Access Compliance Report

(Curb Ramps)

Intersection ID: N/A	Main Street: GERALD_DR	Cross Street: SULLIVANS_TRACE_DR	Location: SW
ADA ID: B3A7071A1648	Ramp Type: PerpDiag	Initial Pass/Fail: Fail	Overall Compliance: No
Severity Score: 33.75			
Codes/Mitigation Info/Possible Solution		Field Measurements/Component Compliance

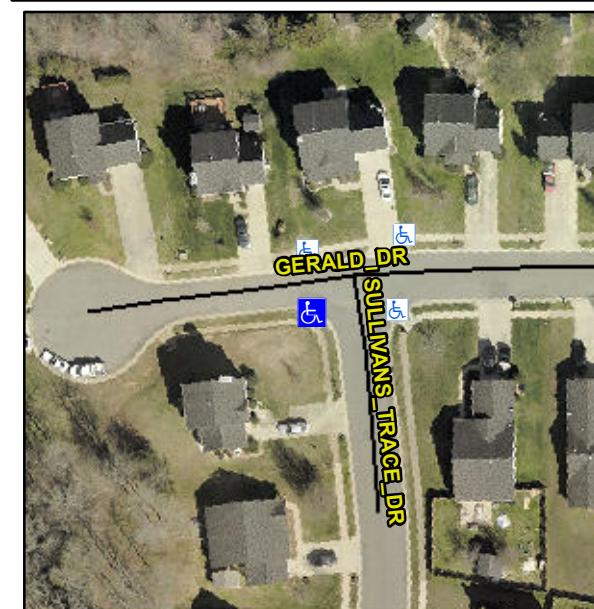
R304.5.1, R304.5.3

Compliance	Description	Data	Compliance	Description	Data
N/A	Ramp Length (in)	51.0	Yes	Ramp Slope (%)	8.2
No	Ramp Width (in)	41.0	No	Ramp XSlope (%)	9.2
N/A	Flare Type LT	N/A	N/A	Flare Type RT	N/A
N/A	Flare Slope LT (%)	N/A	N/A	Flare Slope RT (%)	N/A
N/A	Flare Traversable LT?	N/A	N/A	Flare Traversable RT?	N/A
N/A	Landing Length (in)	N/A	N/A	DWS Provided?	N/A
N/A	Landing Width (in)	N/A	N/A	DWS Contrast?	N/A
N/A	Landing Slope (%)	N/A	N/A	DWS Length (in)	N/A
N/A	Landing X Slope (%)	N/A	N/A	DWS Full Width?	N/A
N/A	Landing Curb? (Y/N)	N/A	N/A	DWS Offset (in)	N/A
N/A	Shared Landing?	N/A			
N/A	Gutter Ponding?	N/A	N/A	Gutter Slope (%)	N/A
N/A	Gutter Lip Ht (in)	N/A	N/A	Gutter X Slope (%)	N/A
N/A	Painted X Walk1?	No	N/A	Painted X Walk2?	No
	X Walk 1 Direction	To E		X Walk 2 Direction	To N
N/A	X Walk 1 Width (in)	N/A	N/A	X Walk 2 Width (in)	N/A
	X Walk 1 Slope (%)	2.0		X Walk 2 Slope (%)	3.0
	X Walk 1 X Slope (%)	3.7		X Walk 2 X Slope (%)	3.3

Remove & Replace Curb Ramp With Two New Directional Ramps or Equivalent.
